**PLAN COMMISSION  
MEETING NOTICE AND AGENDA  
Thursday, September 18, 2025  
6:00 PM**

**Subject:** Redmond Residence – N37W26697 Kopmeier Drive  
Mitigation Plan

**Subject:** Krueger Residence – N27W27128 Woodland Drive  
Mitigation Plan

# PLAT OF SURVEY

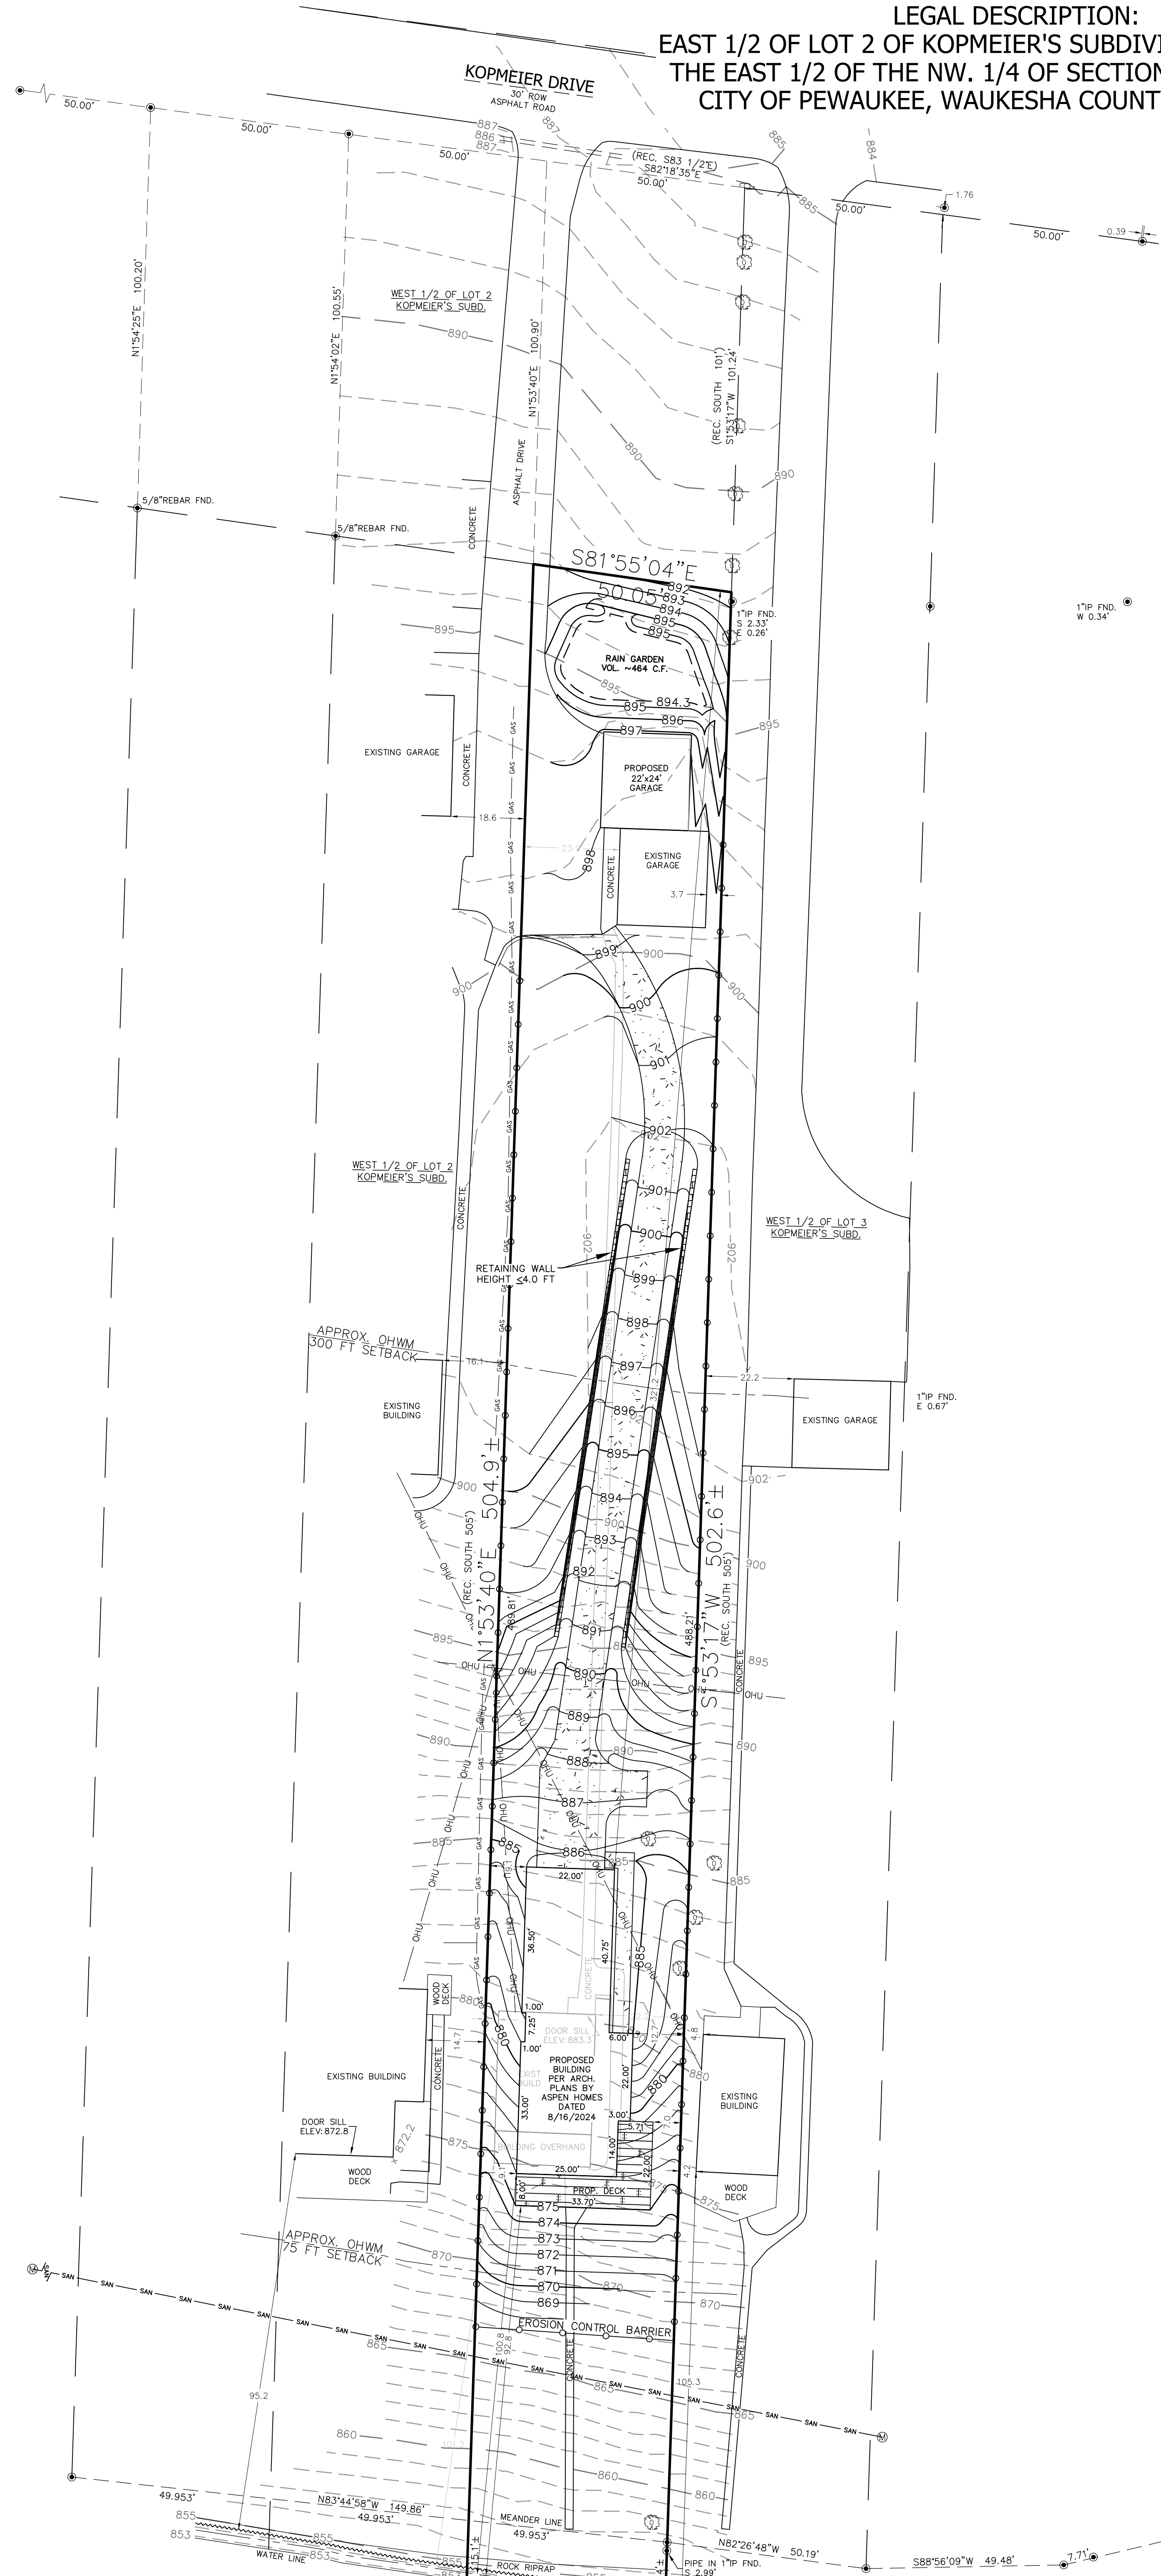
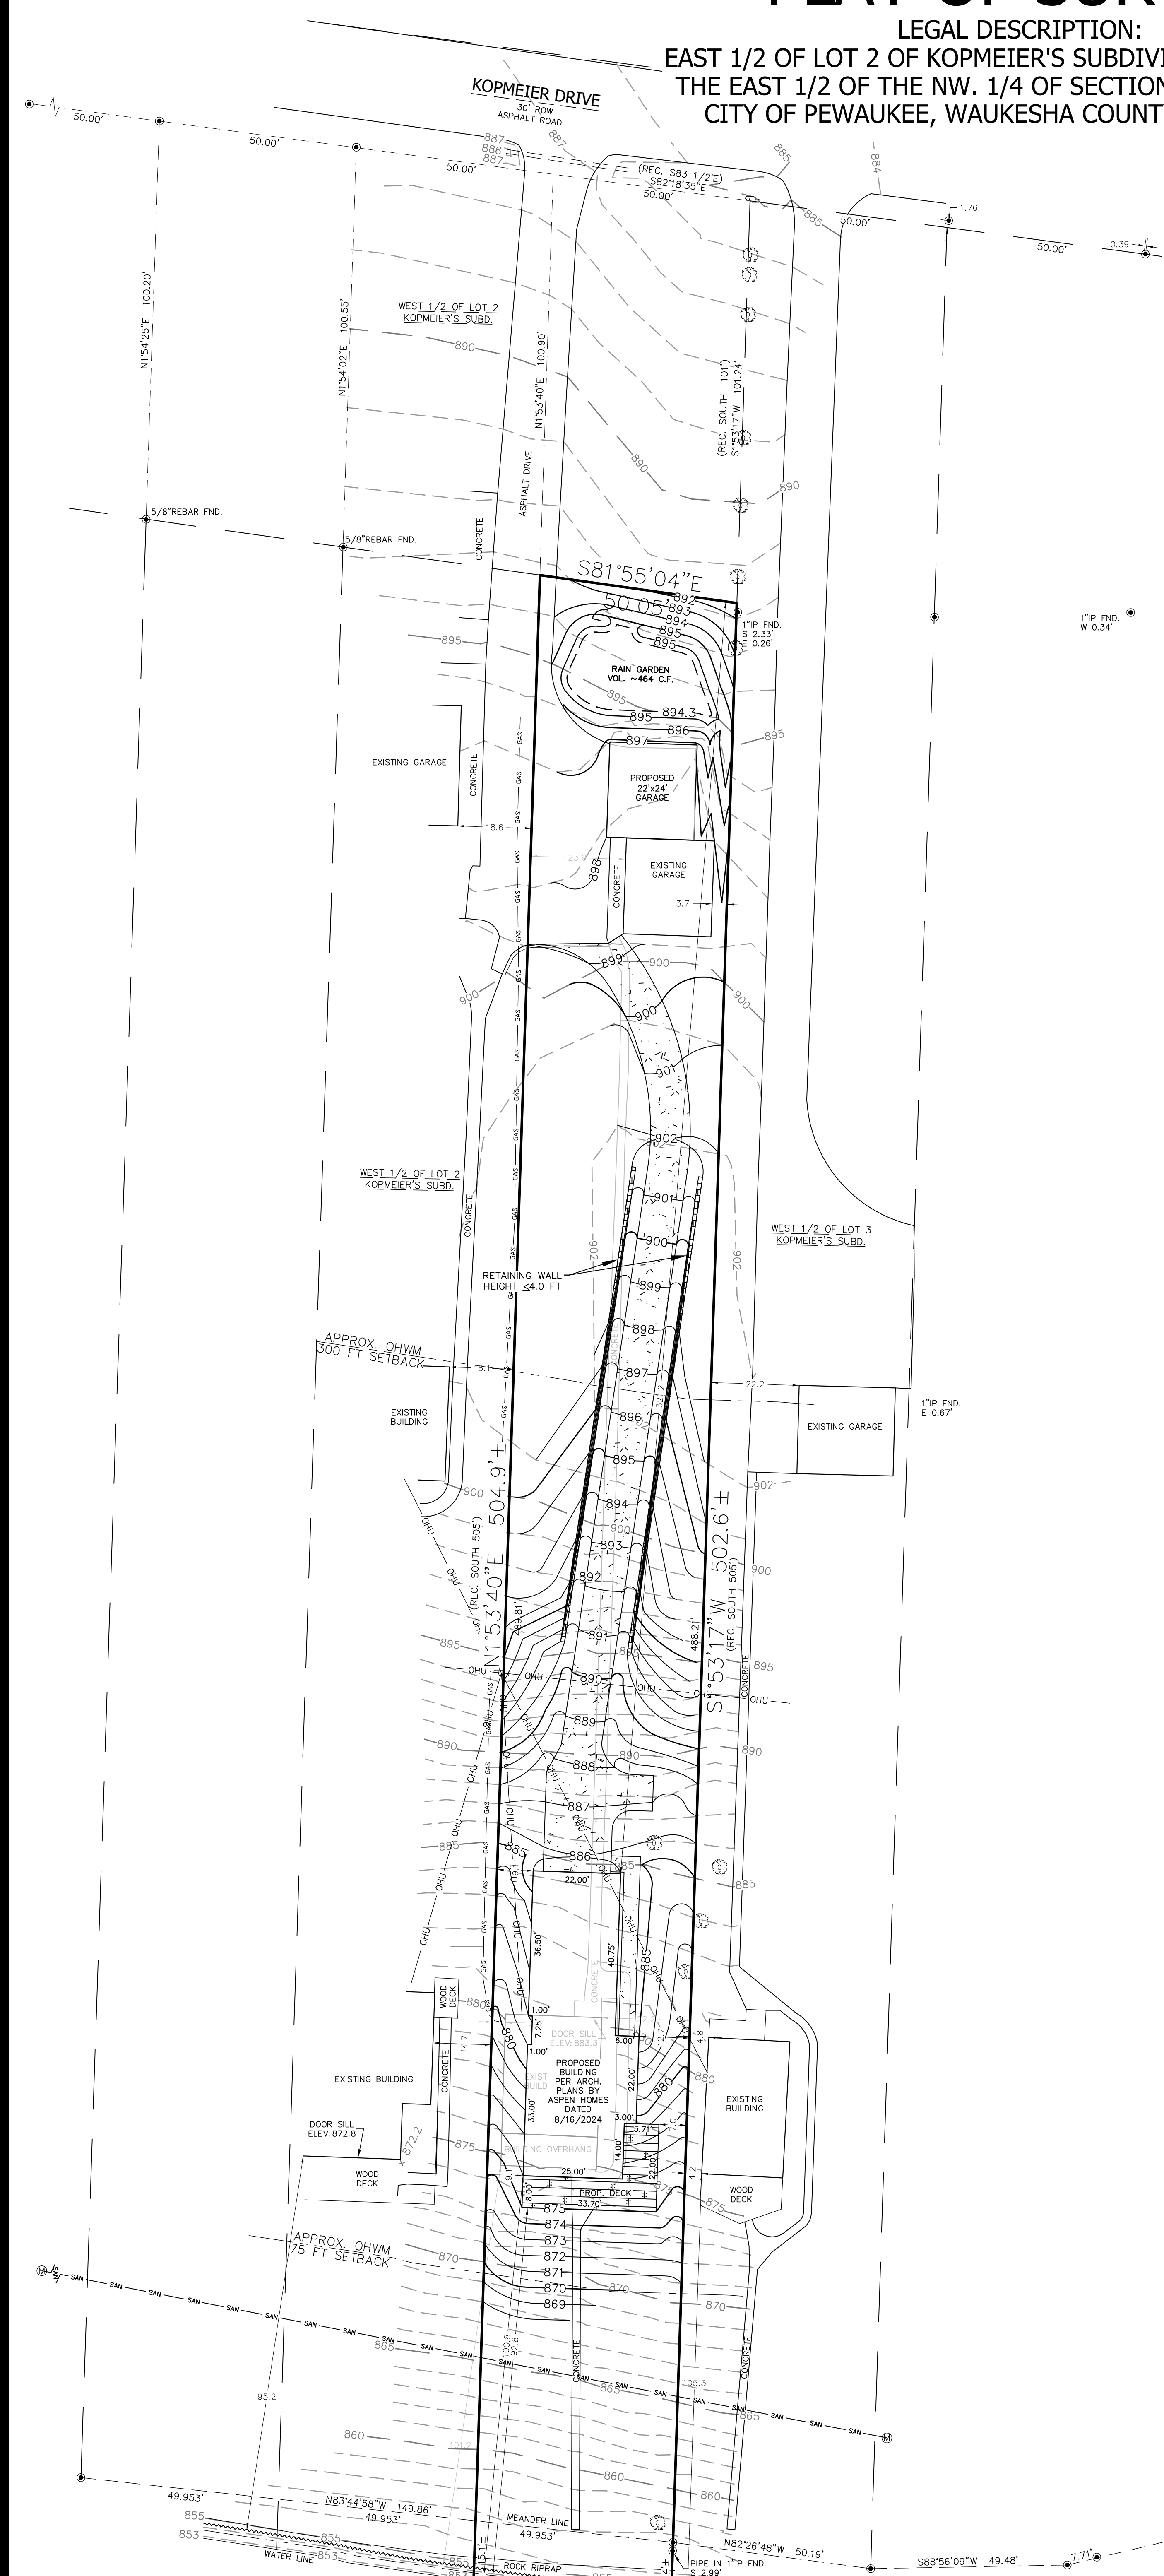
The rain garden is adequately sized to provide the required mitigation.

We approve the mitigation plan contingent on the following:

1. The mitigation plan narrative, plan, and the Plan Commission minutes are recorded at Waukesha County (City provided a recorded copy) as required in the ordinance using the Recording Template previously provided to the owner.

# GRADING AND EROSION CONTROL PLAN

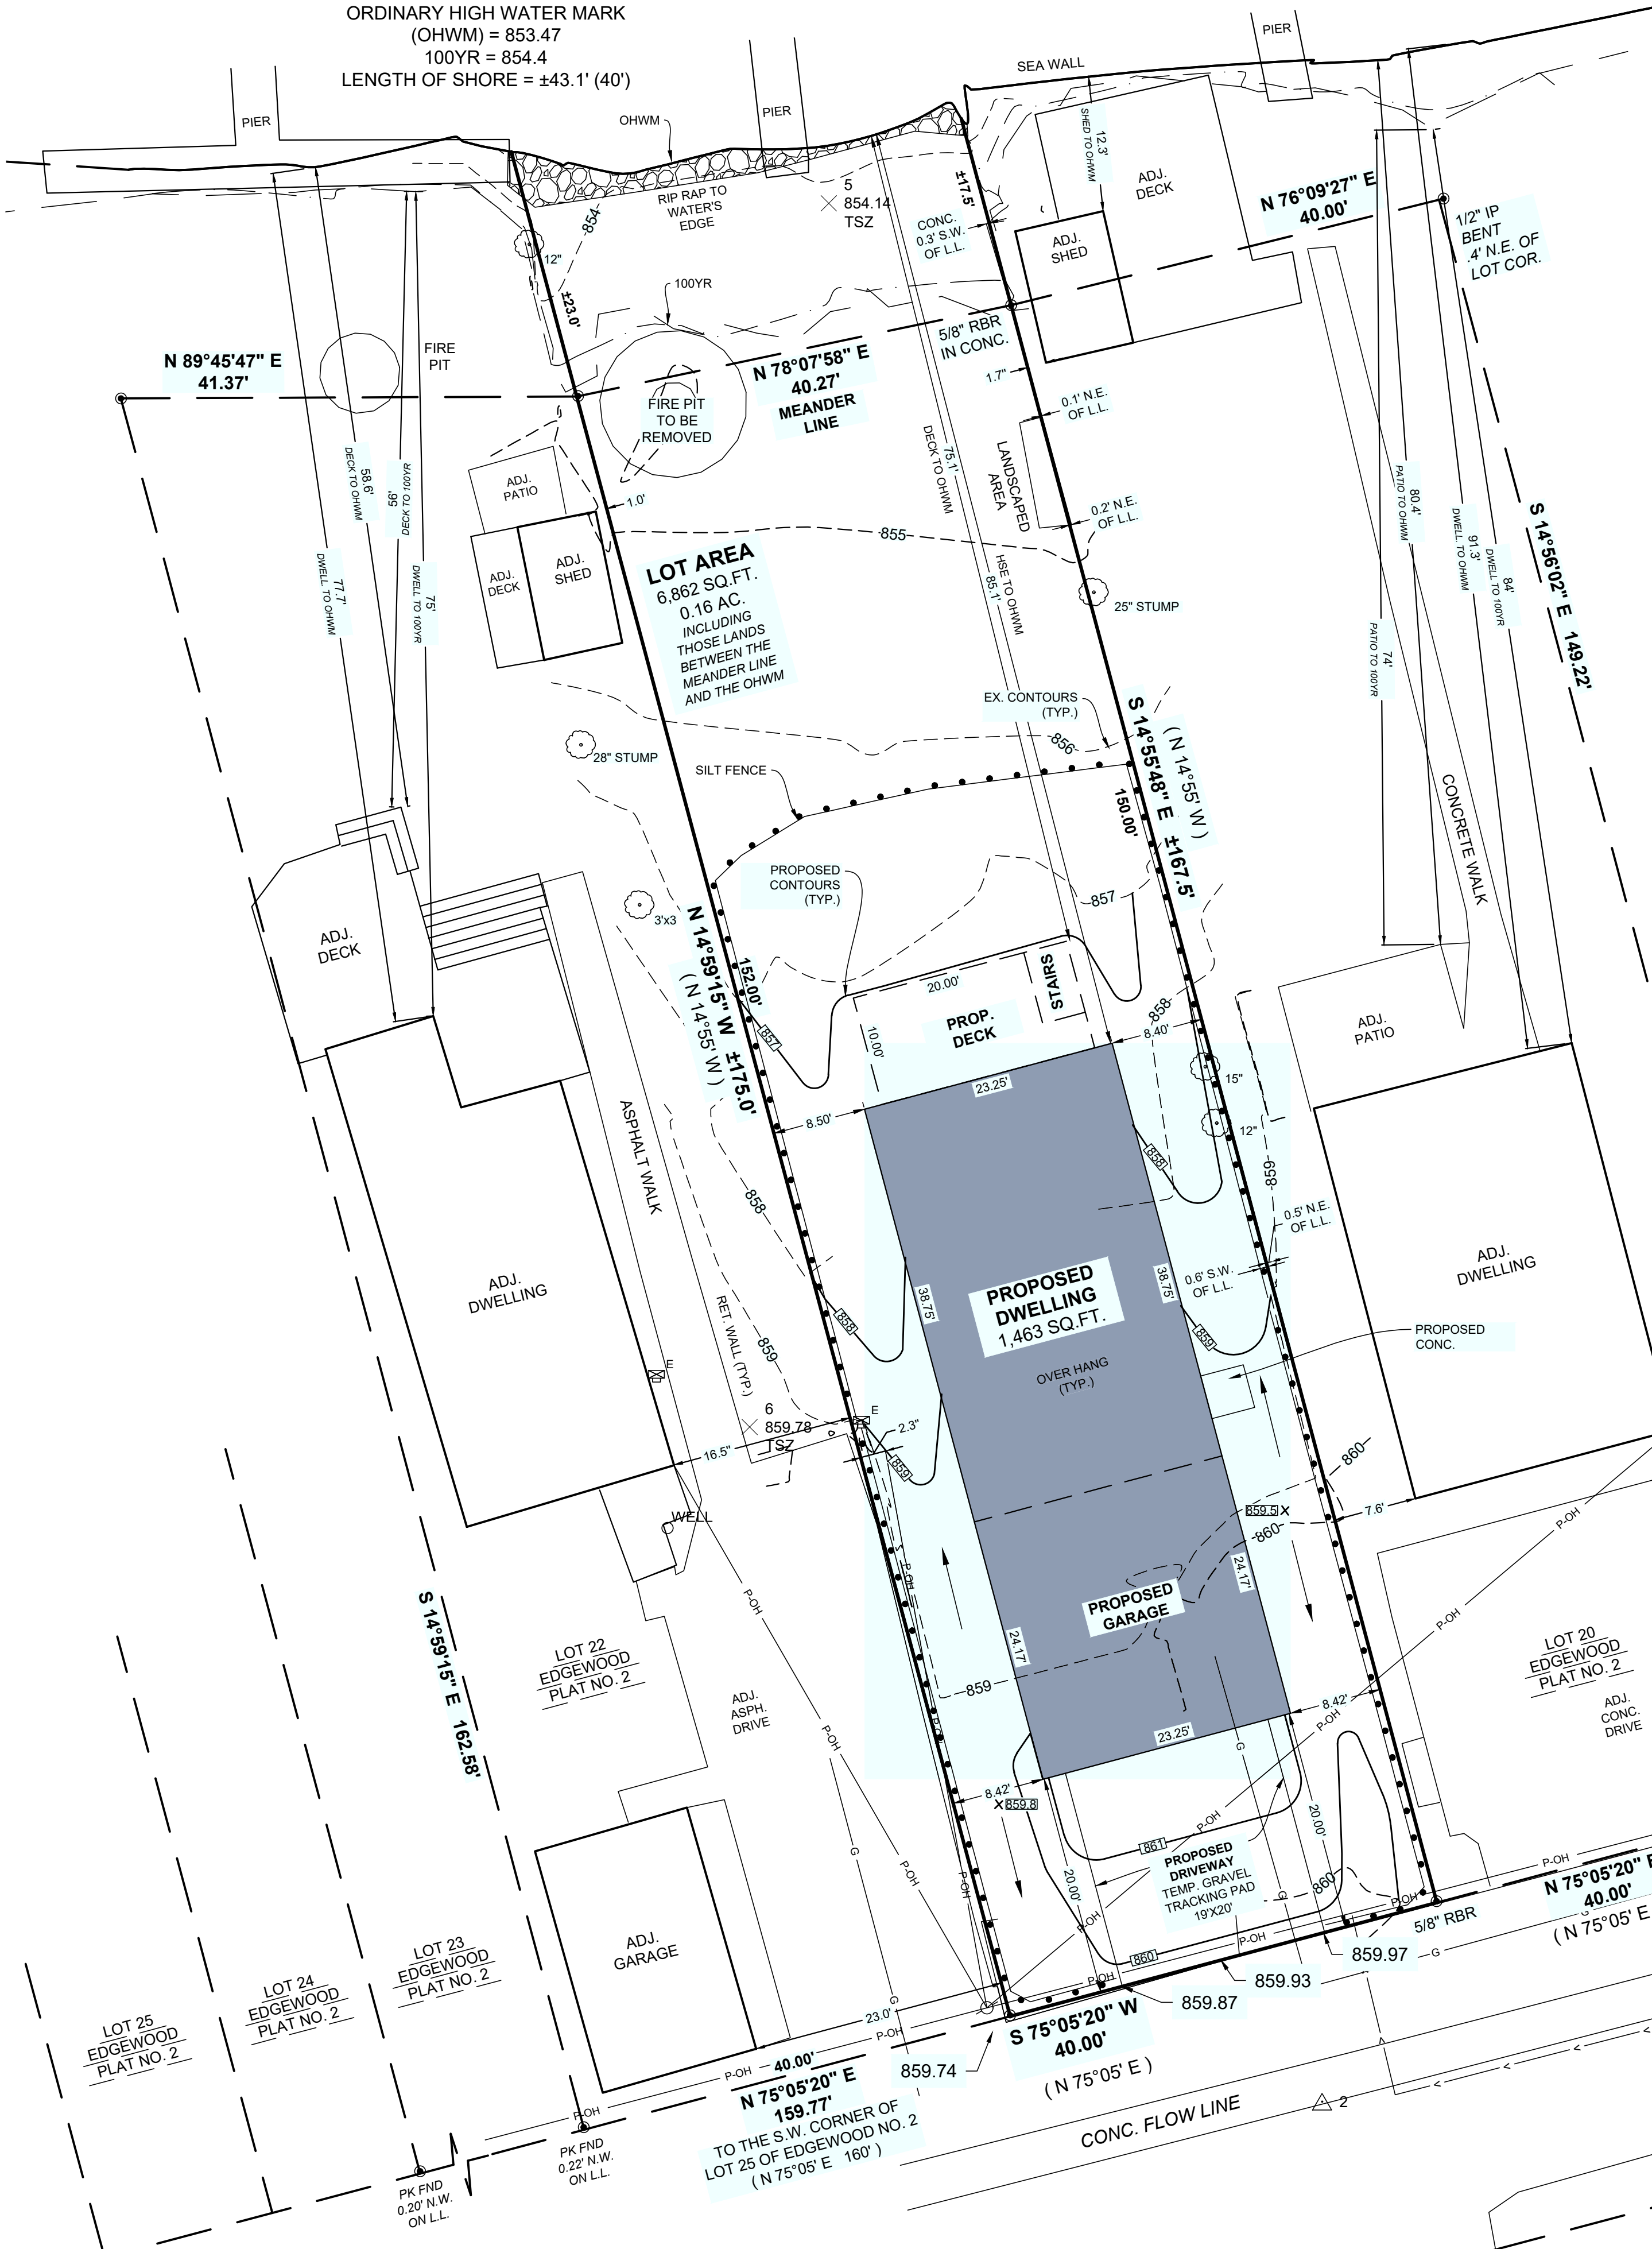
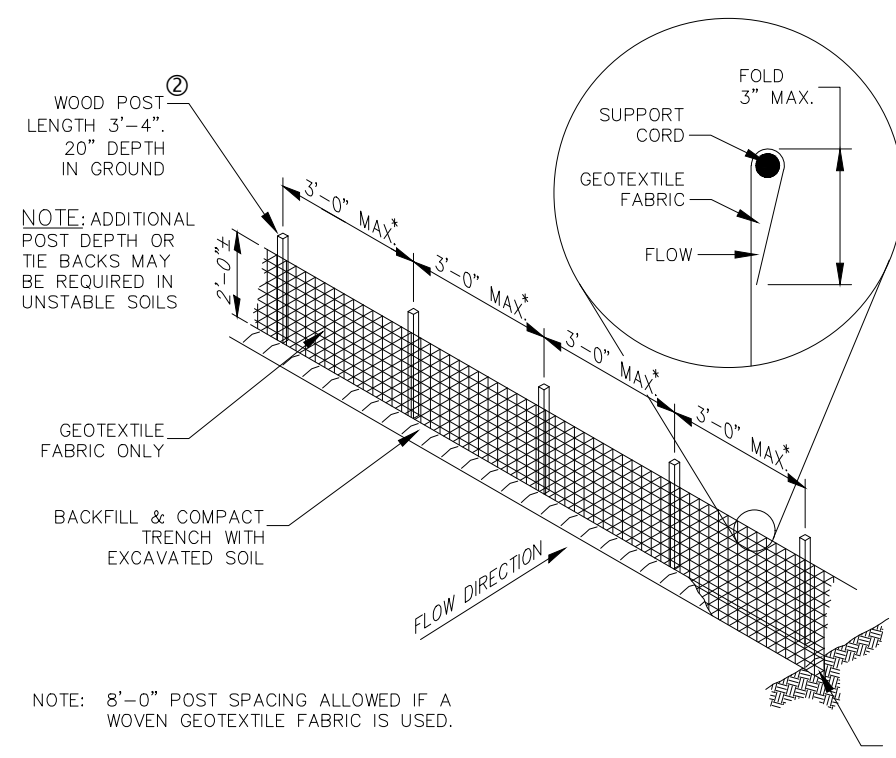
The rain garden is adequately sized to provide the required mitigation.

We approve the mitigation plan contingent on the following:

1. The mitigation plan narrative, plan, and the Plan Commission minutes are recorded at Waukesha County (City provided a recorded copy) as required in the ordinance using the Recording Template previously provided to the owner.
